Official Transcript of Proceedings
NUCLEAR REGULATORY COMMISSION

Title: Advisory Committee on Reactor Safeguards
 AP1000 Subcommittee: Open Session

Date: Tuesday, April 5, 2016

The purpose of this meeting is to review the exemption request in the Levy Nuclear Plant Units 1 and 2 Combined License Application. These exemption requests include departures from the AP1000 certified design, which contain: one, passive core cooling system condensate return; two, main control room dose; three, main control room heatup; four, hydrogen venting inside containment; and, five, neutron flux doubling algorithm compliance with IEEE-603. So there are five exemptions, we

Heat Loss Through Pressurizer

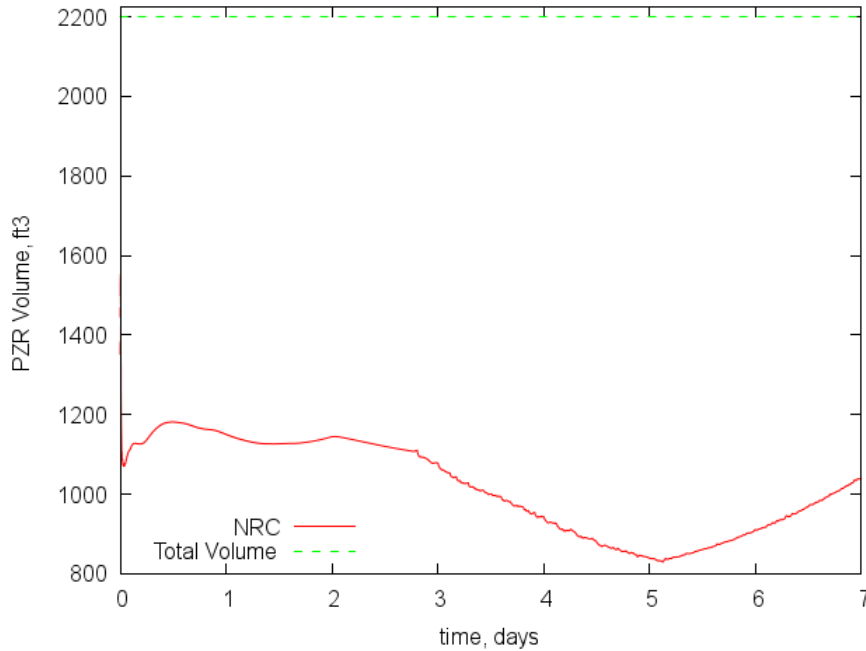
- Primary heat loss concern from RCS is through pressurizer
 - Has insulated and uninsulated surfaces
 - The uninsulated surfaces (supports, heater sheaths) account for almost half of the heat losses through the PZR under certain conditions
- Analyses performed to justify effective heat transfer coefficient (HTC) applied to PZR outer surface in RELAP5 and LOFTRAN
 - Effective steady-state HTC conservatively bounds transient conditions
 - Modeling of PZR heat losses is conservative:
 - Consistent with NRC staff calculations
 - Supported by data from literature

- Staff confirmatory analyses indicate a further margin of 50% could be applied to the heat losses and have the RCS remain subcooled for a minimum of 72 hours
- Multiplication factors used to account for heat losses beyond through-insulation heat loss are supported by data from literature
 - Laboratory testing showed through-insulation ranged from 28% to 52% of total heat loss
 - Convective air flow will be reduced significantly during SBO

Loss of Subcooling Transient Analysis

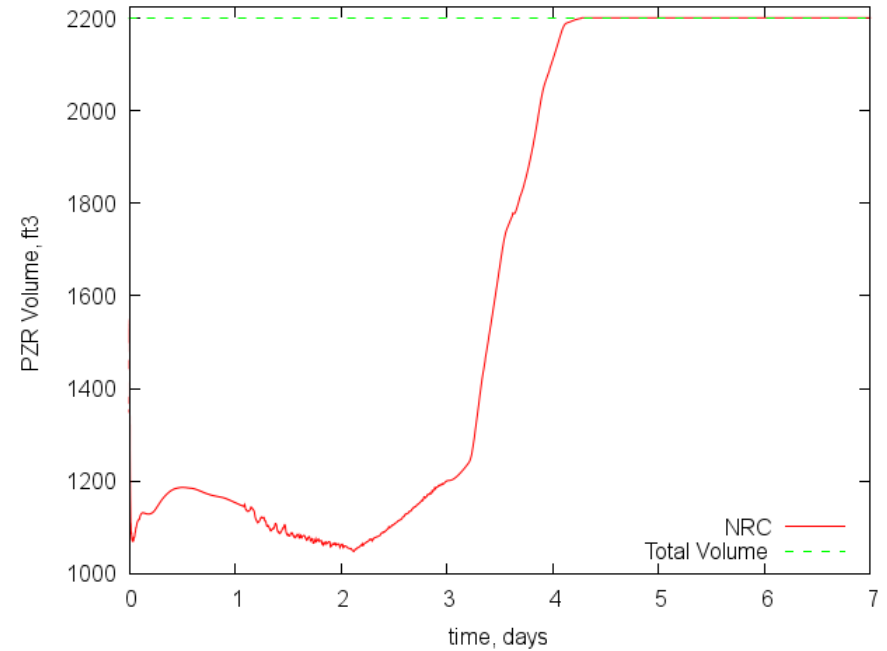
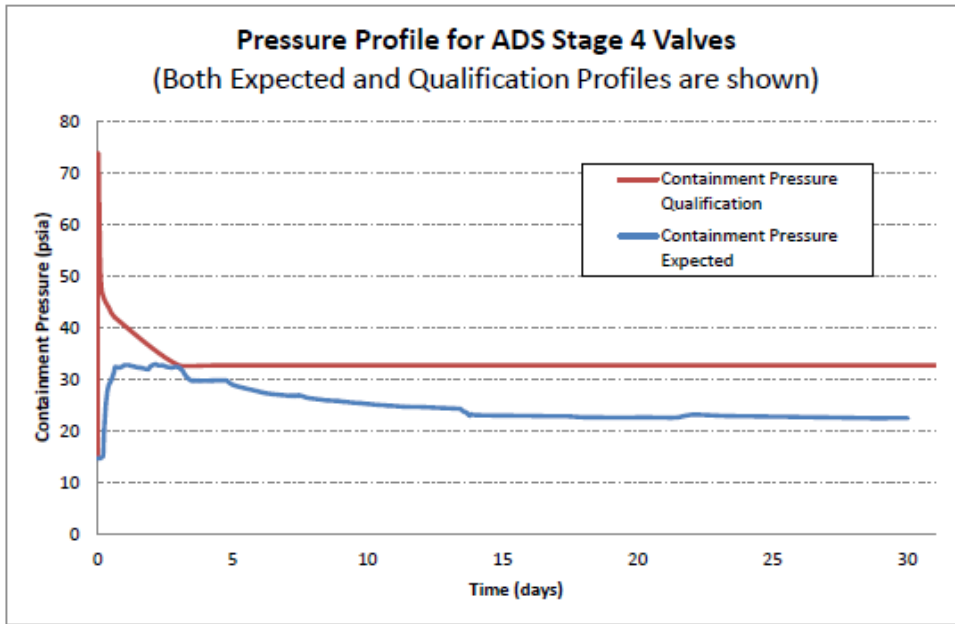
- DBA analyses show loss of subcooling does not occur within 72 hours
 - Ambient heat losses do not adversely impact Chapter 15 DBA analyses
 - Consistent with staff confirmatory analysis
- No adverse impact to safe shutdown analysis (420 F in 36 hours)
- Analyses show loss of subcooling occurs within 14 days
 - PRHR HX performance does not degrade
 - Supported by test results from APEX facility (NRC SBO testing for AP600 and AP1000)
 - Consistent with staff confirmatory analysis

Transition to Open Loop Cooling Equipment Qualification Envelope

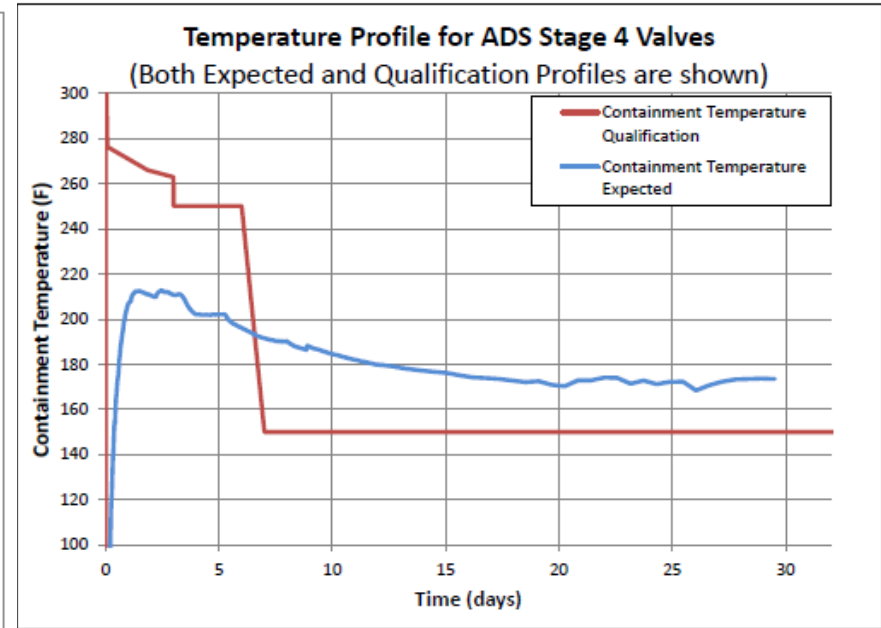
1 So this next slide, it shows the analysis done by the applicant in part of the RAI
2 response and this shows an EQ envelope as well as expanded containment conditions during an
3 extended event that would use passive RHR.

7 So to resolve that issue, they did a scaling analysis using the Arrhenius Equation
8 and they were able to show that the scaled EQ envelope does bound these containment conditions
9 over 30 days.

MCR Temperature and Humidity

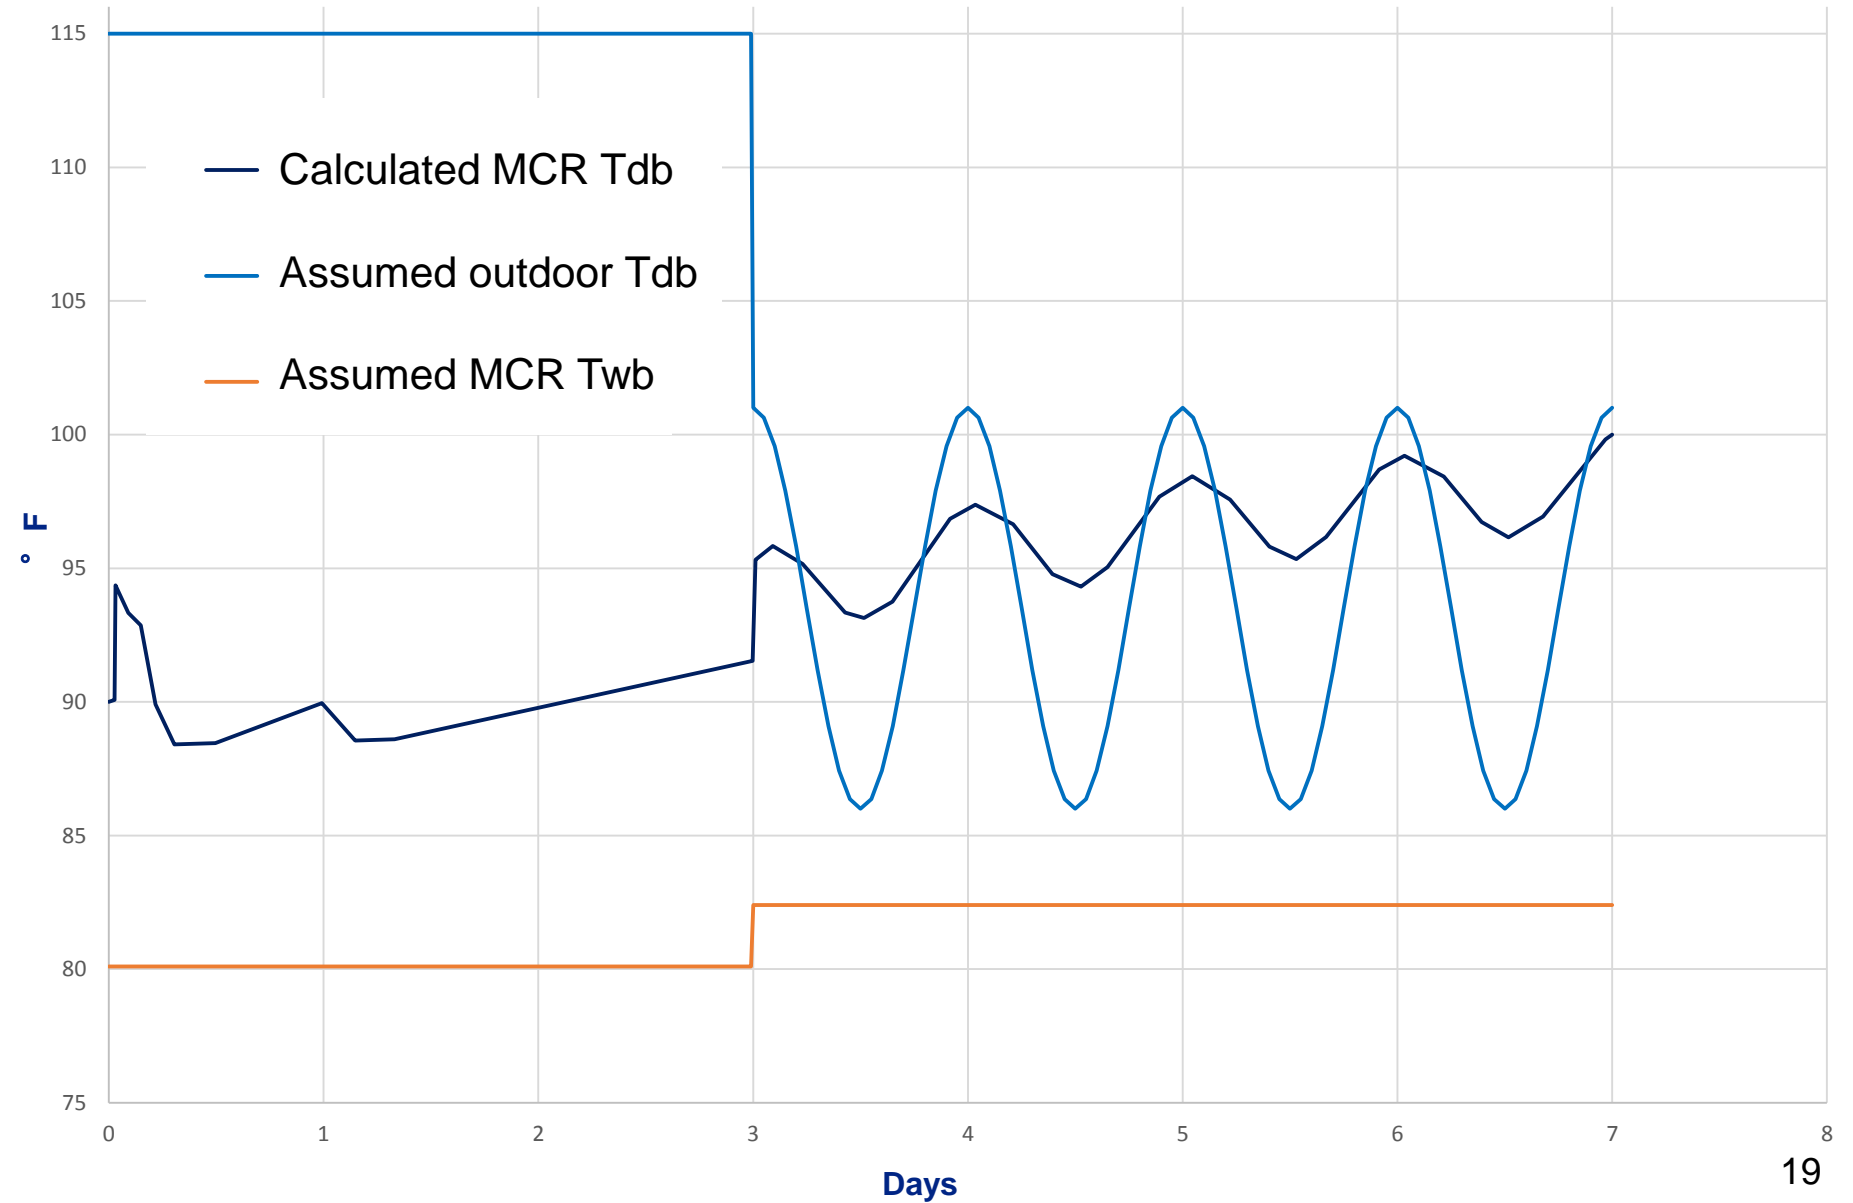
- Two periods of interest:
 - 0-72 hours (VES in operation)
 - 3-7 days (ancillary fans in operation)
- New heat load (result of revisions to heat loads plus addition of load shed) in GOTHIC analysis changes temperature profile
- Due to acceptance criteria, both dry bulb and wet bulb temperature (humidity) are important parameters
 - Human Performance: WBGT < 90 F
 - Equipment Qualification:
 - 0-72 hours - < 95 F and 60 % Relative Humidity
 - 3-7 days - < 110 F and 35 % Relative Humidity

- Staff reviewed GOTHIC analysis and found it conservatively captured dry bulb MCR temperature with the new heat load and load shedding (profile on slide 19)
- Applicant assumed a constant ambient dry bulb temp. of 115 F
- Humidity calculated separately by applicant
 - Value asymptotically approaches steady state, due to dry air input from VES bottles and subsequent leakage from the MCR
 - Applicant used initial conditions of 75 F, 60% RH (the nominally limiting values) to determine that assumed value was conservative
 - While staff agrees that those values are the highest expected in the MCR, staff performed a confirmatory calculation using 75 F, 100% RH (TS limited value) and found that maximum T_{wb} was ~79 F, less than the 80.1 F assumed in the analysis
- MCR substantially lower than 90 WBGT during first 72 hours
